City of Portland, Maine – Building or Use Permit Application 389 Congress Street, 04101, Tel: (207) 874-8703, FAX: 874-8716

DATE: 26 Mar, 98 ADDRESS: 14 Centenna / ST. (P.I.) (087-pp-pp7)
REASON FOR PERMIT: Change of use from 3-Fam To 1-Fam dwelling
BUILDING OWNER: William & Patty Zimmerman
CONTRACTOR: Whites Arch.
PERMIT APPLICANT: _____
USE GROUP R-3 BOCA 1996 CONSTRUCTION TYPE 3-B

REASON FOR PERMIT: change of use from 3 to 1 unit with renovations and
rebuild on top of 1st floor deck

project: Zimmerman Residence, Peaks Island
re: Structural inspections issues
cc: Leddy Houser Associates fax 871-5995

A

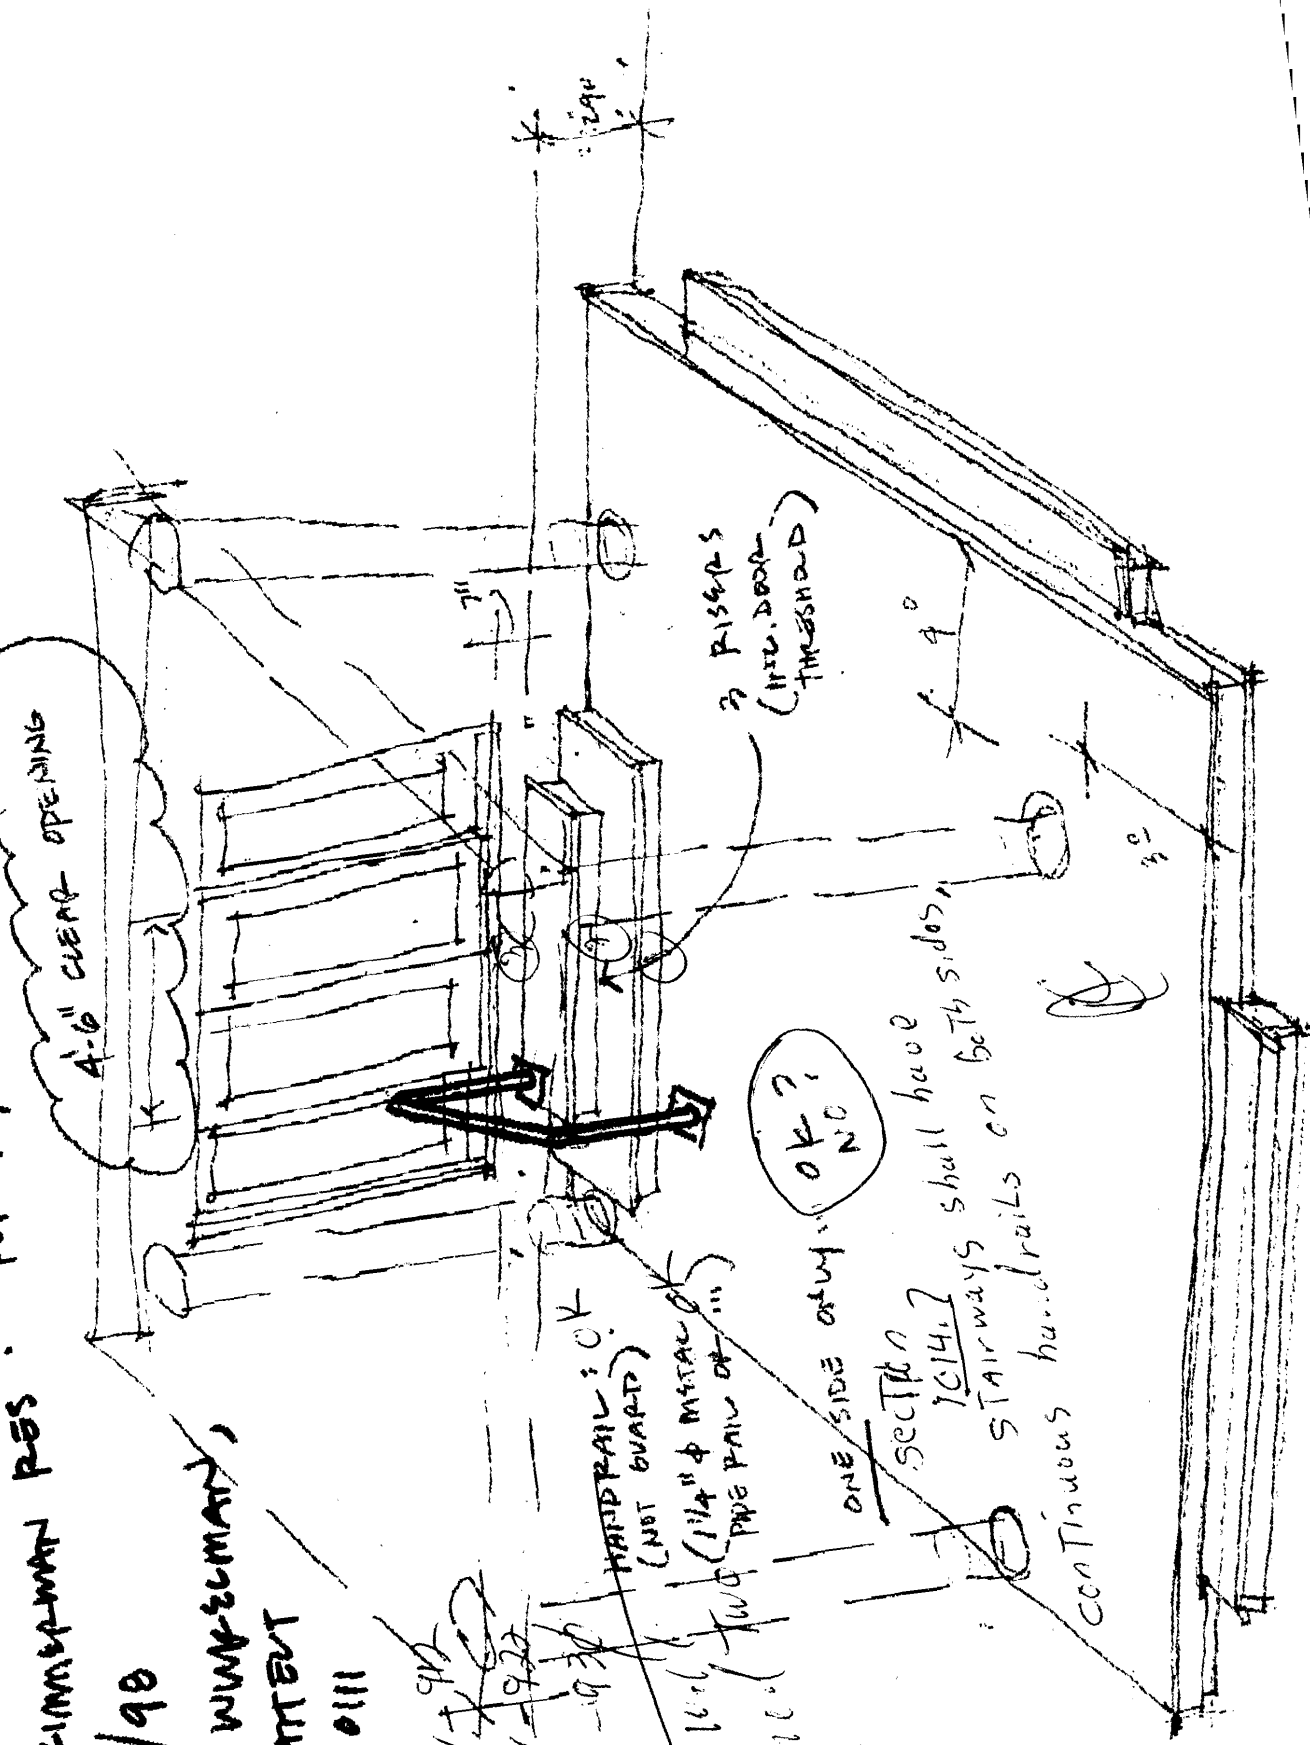
POUCH / STEPS / RAIL ISSUE

HANDRAIL: OK
(NOT GUARD)
(1 1/4" & METAL
PIPE PAIR @ 11")

ONE SIDE ONLY OK?
NO

SECTION 1014.2
STAIRWAYS shall have
continuous handrails on both sides

B

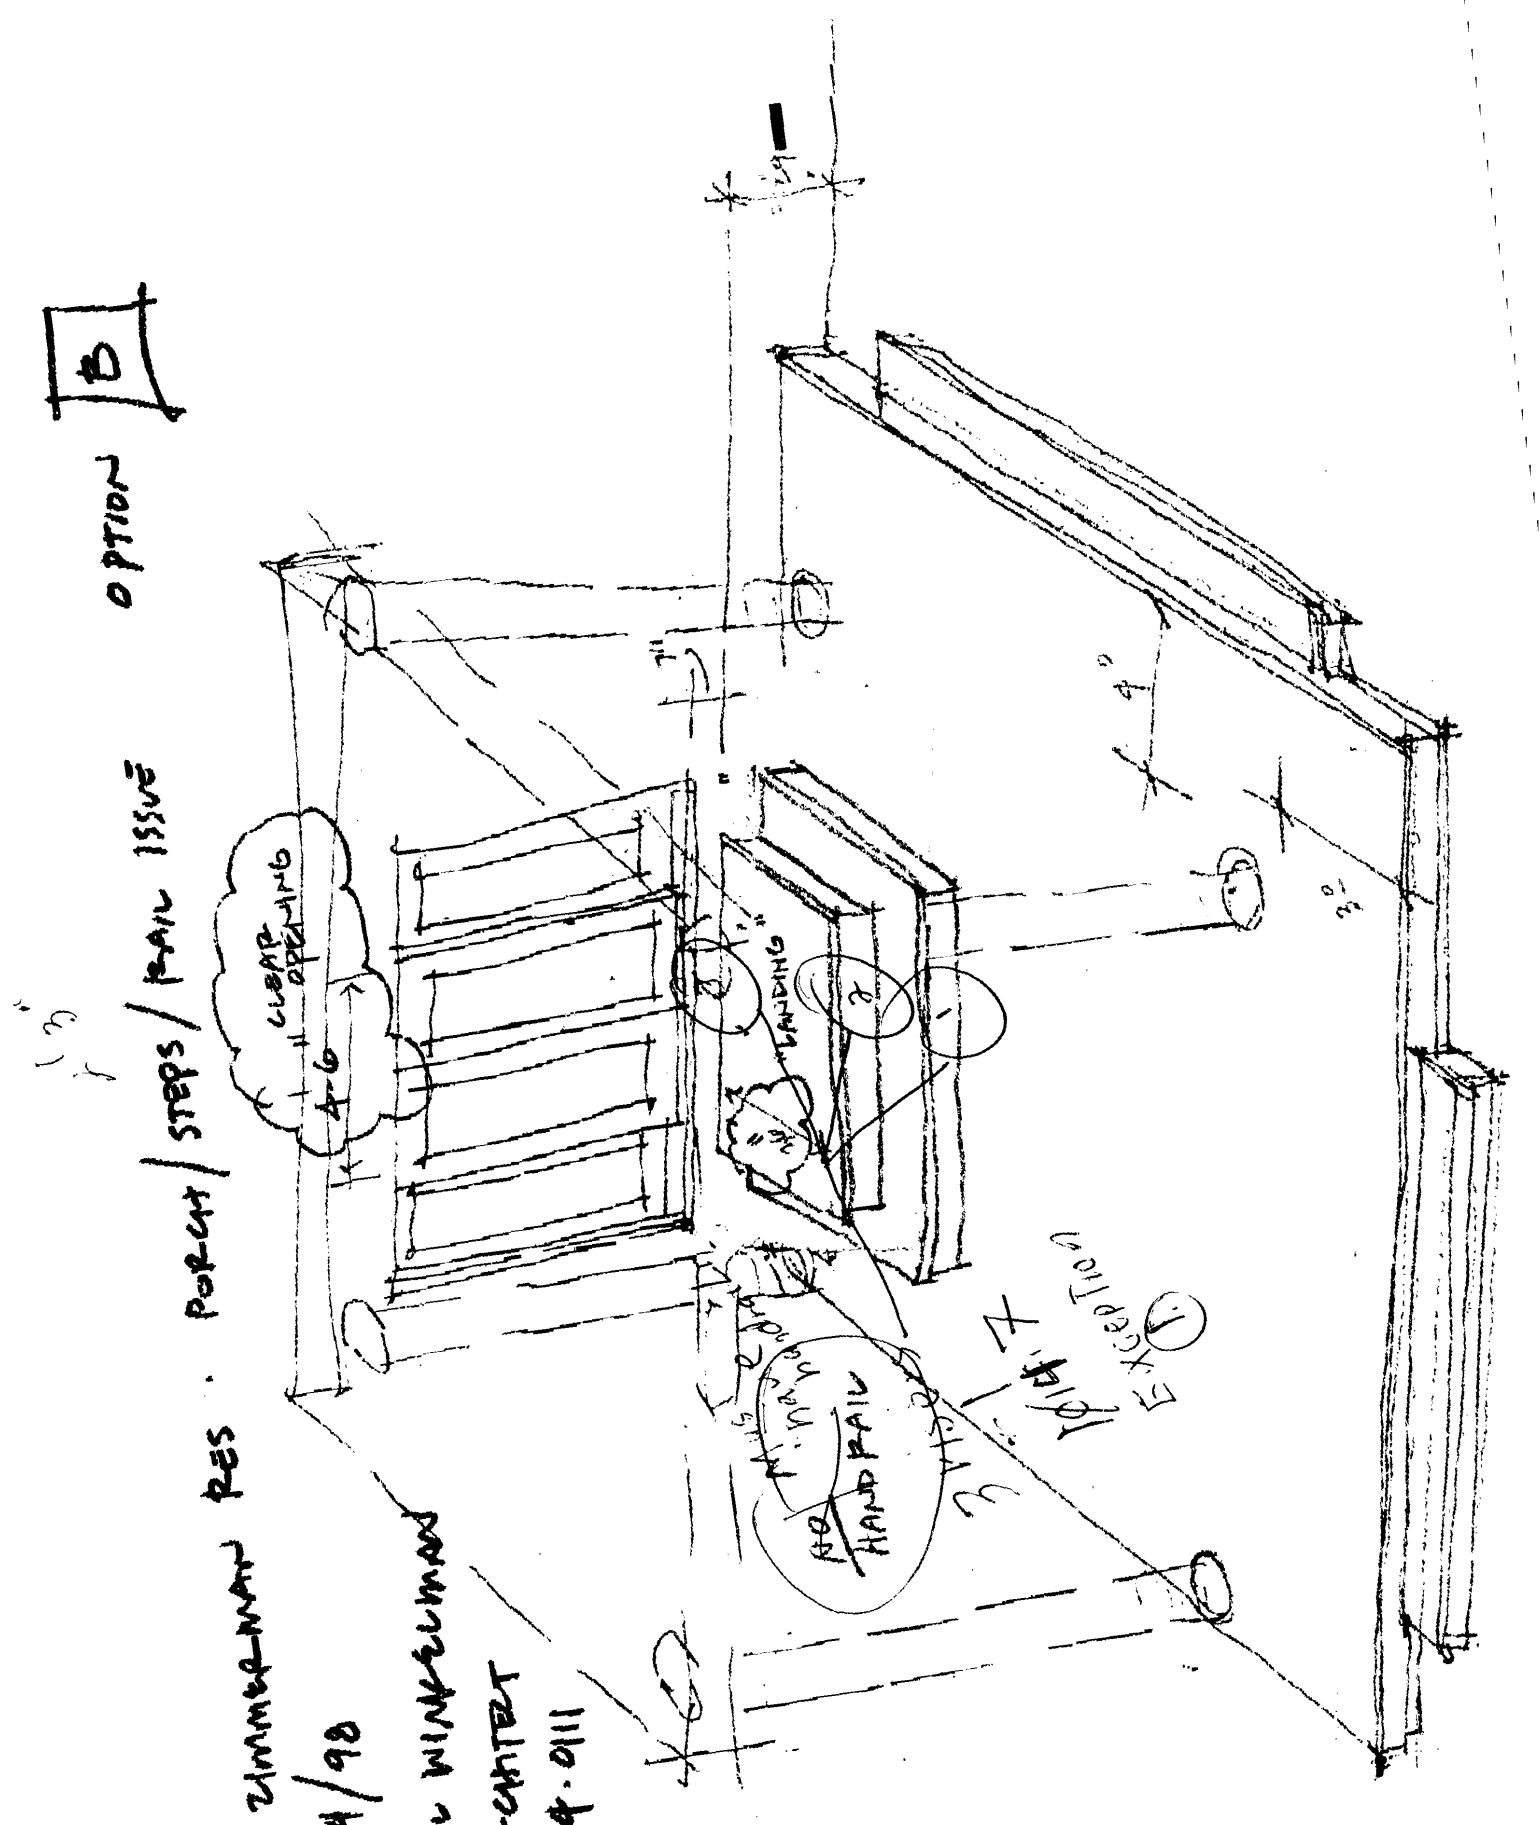
parent / steps / pain issue

NO HANDRAILS
HANDRAIL

EXCEPTION
